CM ADDENDUM NO: One (1)

PROJECT: Housing Authority of the Cherokee Nation Phase II
Ganhili Addition – Jay, OK

To:	Bidding Documents Plan-Holders of Record Project File	Date:	April 25, 2024
		Addendum Number:	
		Architect's Project #:	20230079
		Project Name:	Ganohili Housing Development (Jay)
From:	BLUE RIVER ARCHITECTS, LLC 320 South Boston, Suite 103 Tulsa, Oklahoma 74103 Tel 918.877.9036	Professional Seal:

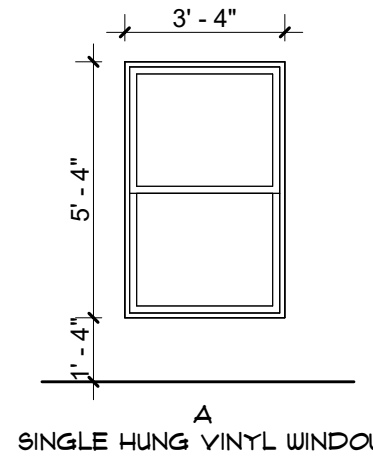
4. **Question:** The vented soffit doesn't specify what material it is, can you provide additional information like material type and thickness?

Answer: Norandex 12" Soffit – AST12fv – or approved equal.

SHEET NUMBER: **P101**

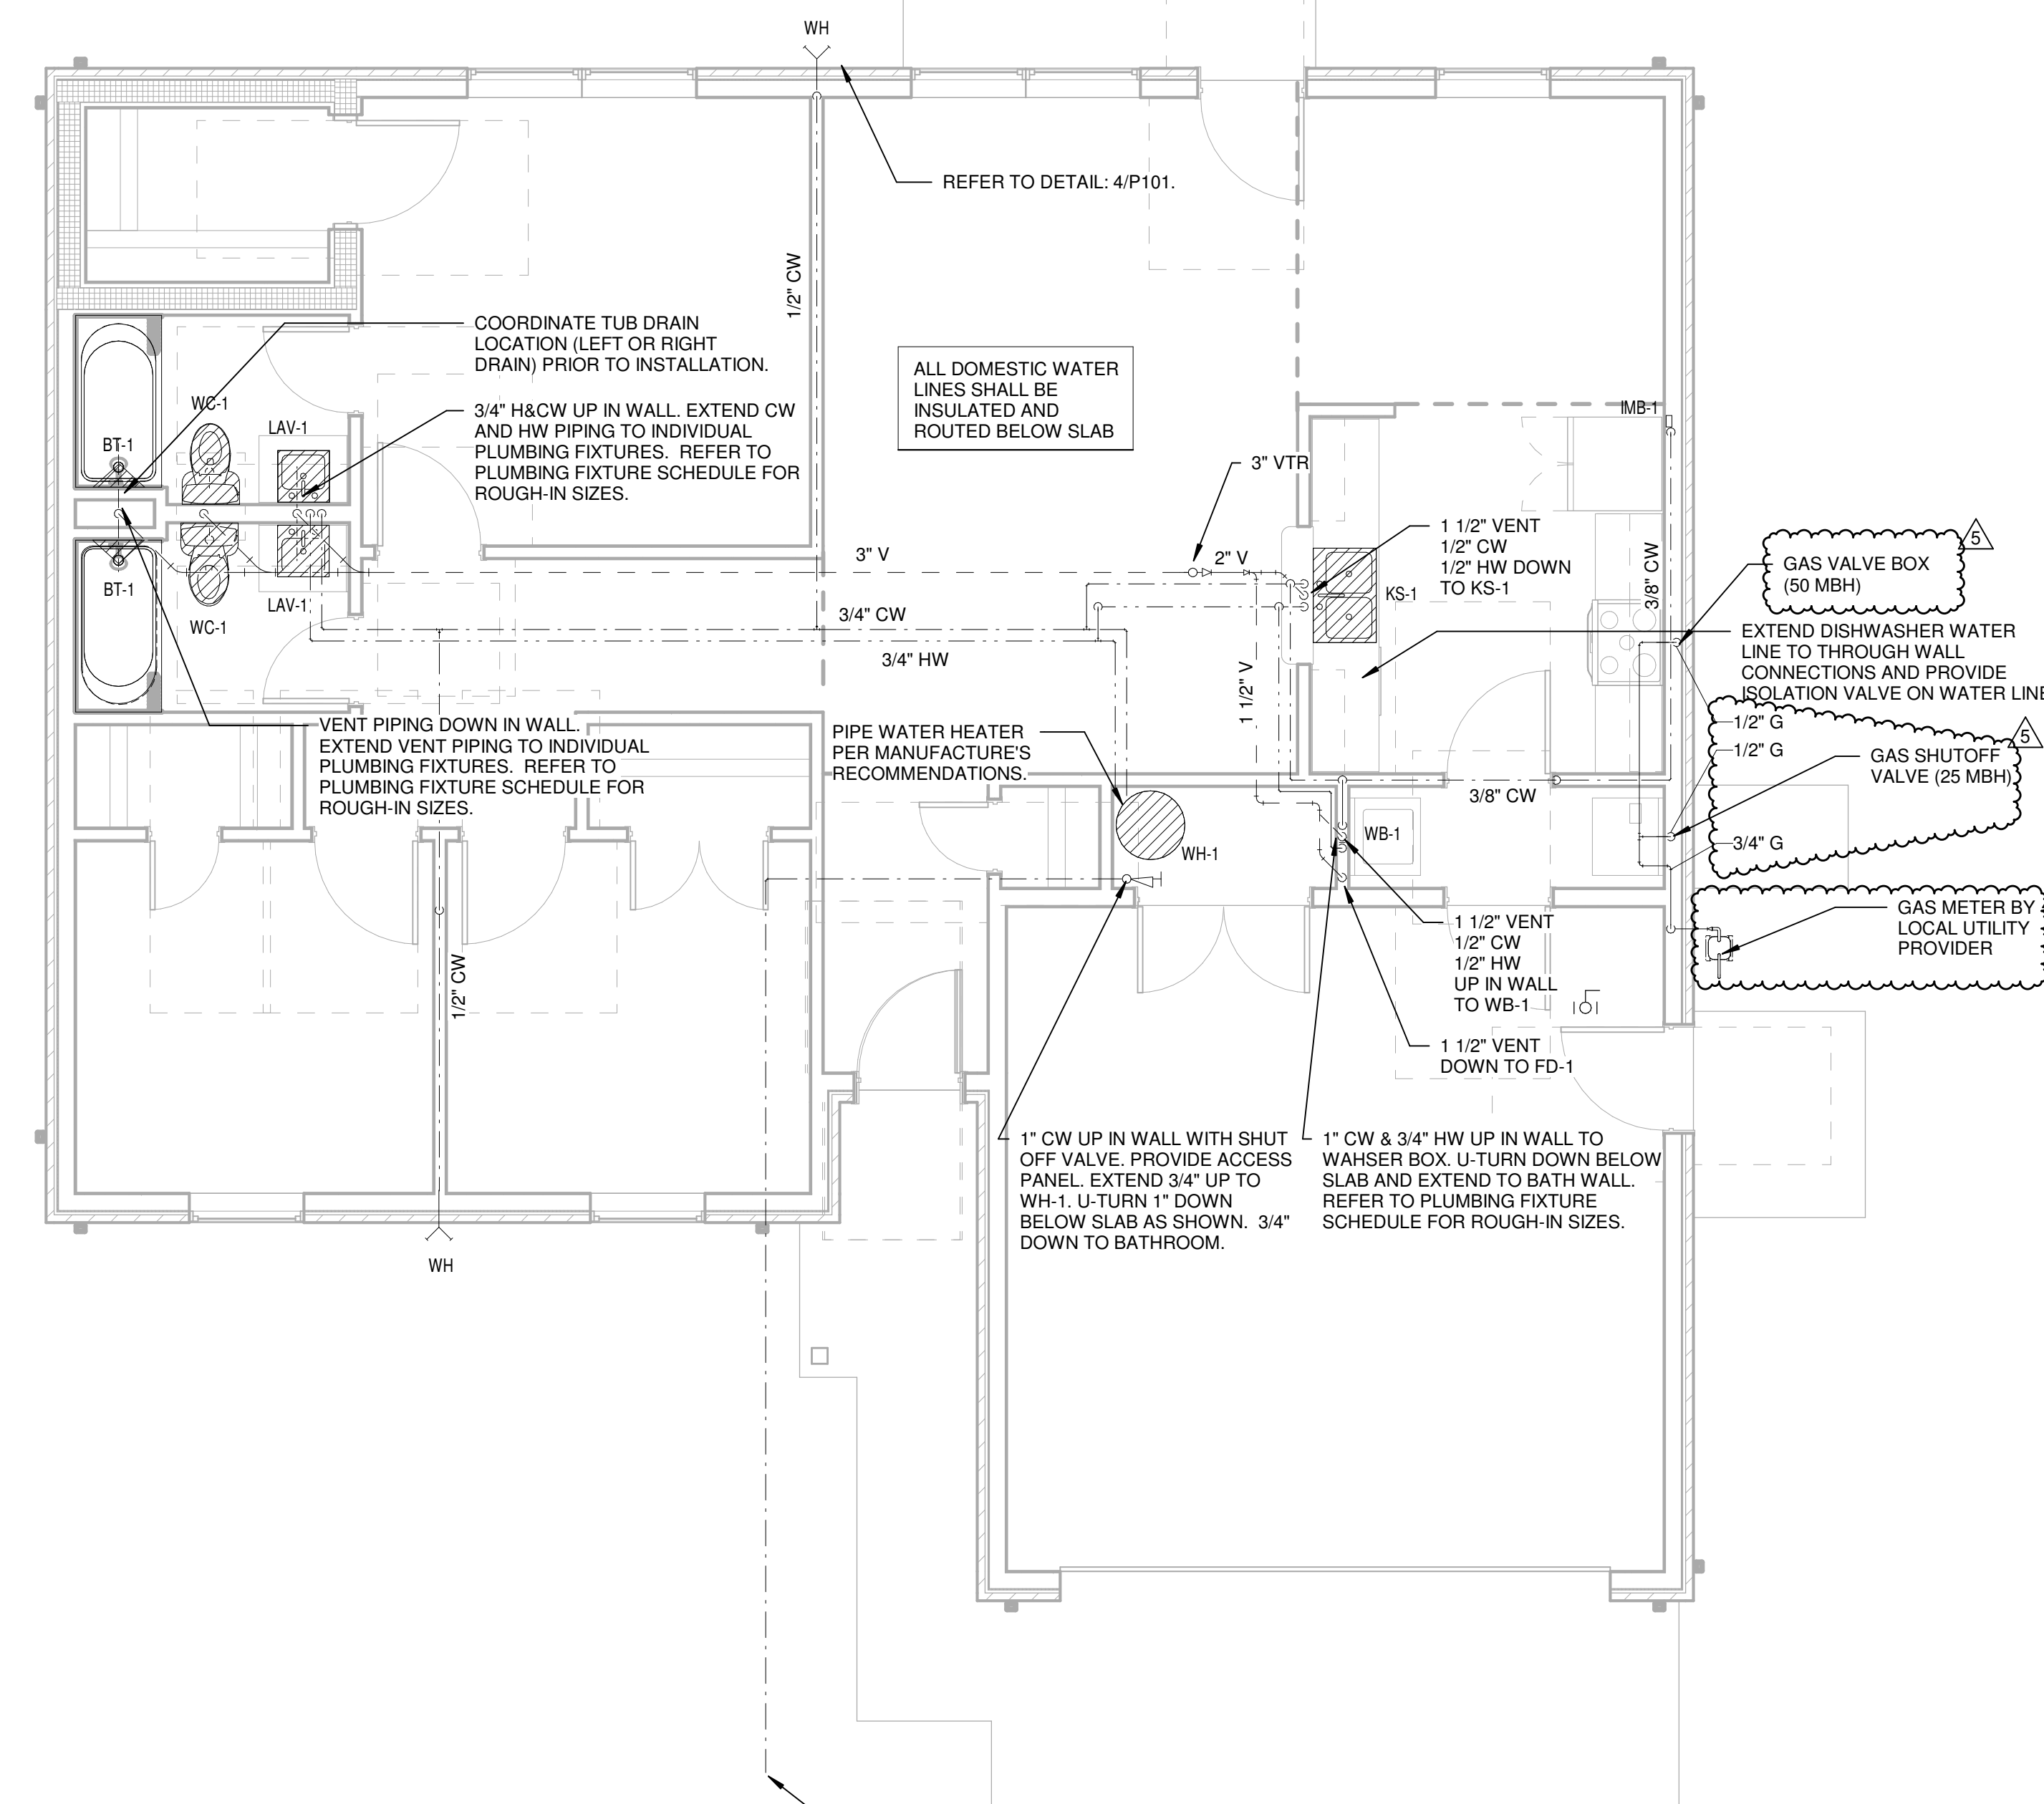
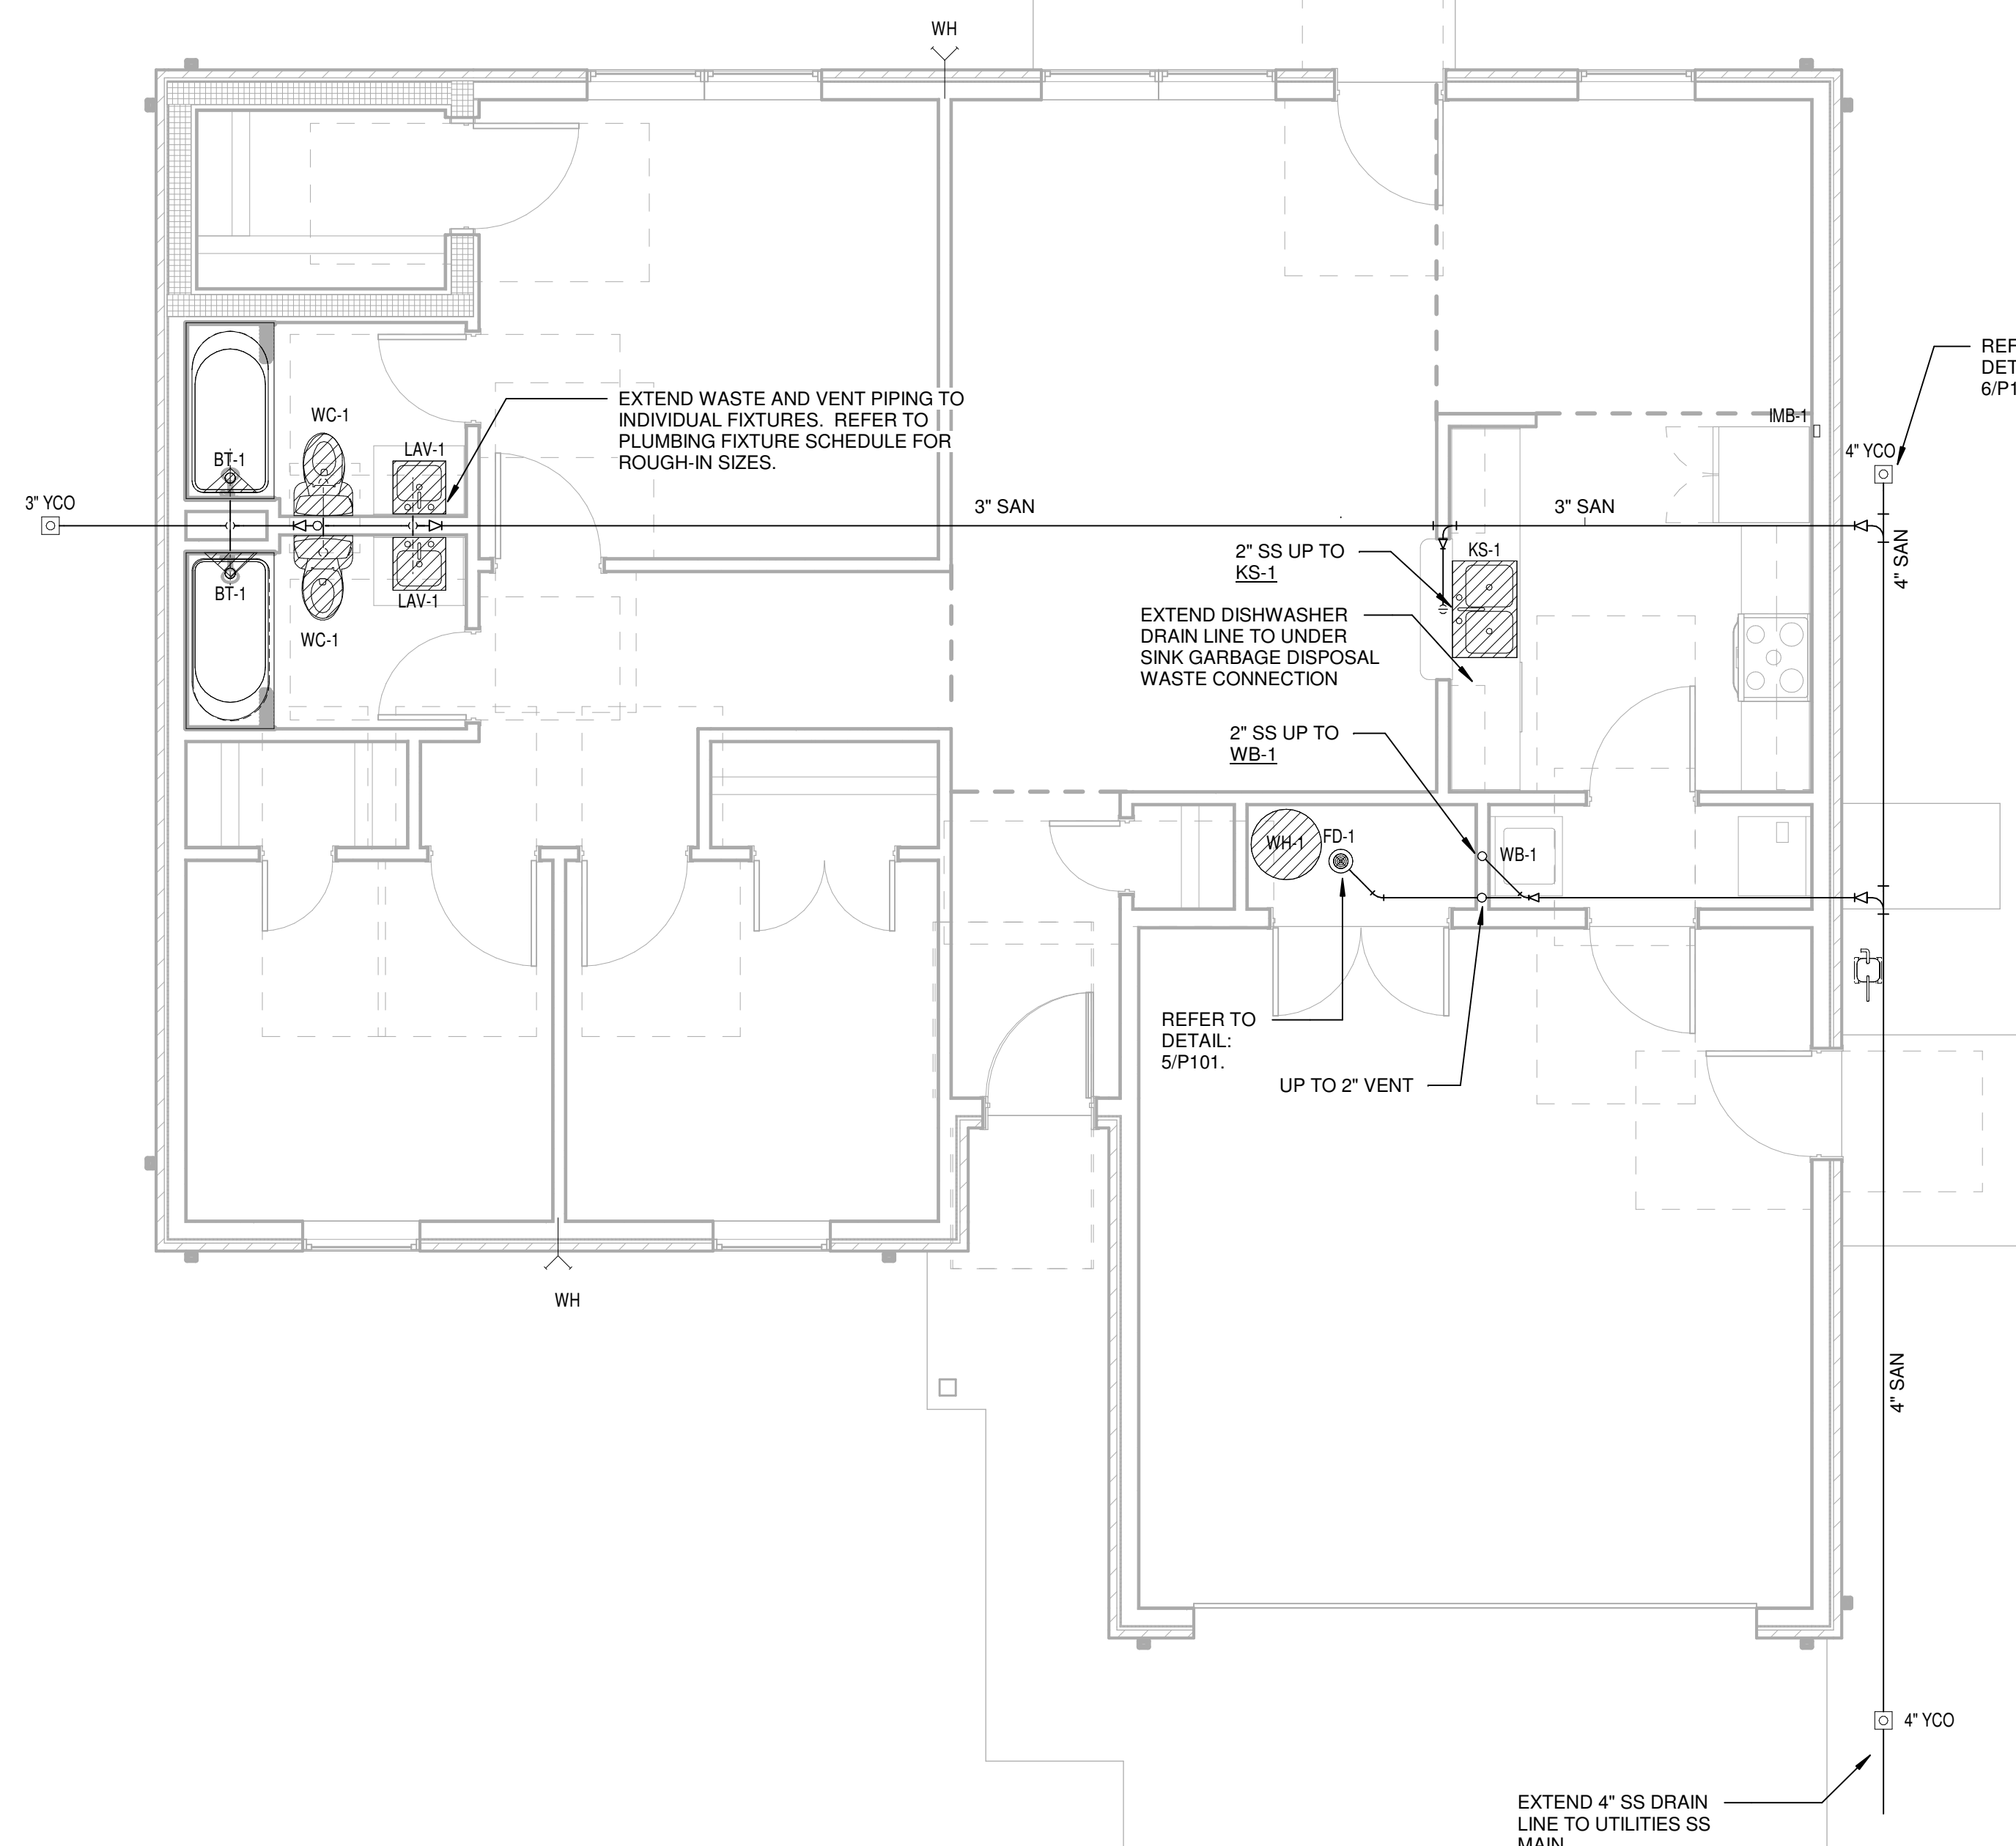
5. **Question:** The drawings do not reflect a gas line for the stove or dryer. i know there was discussion about the gas with the new energy requirement, but I thought the housing authority did want a drop for one of those.

Answer: See attached, revised sheets.
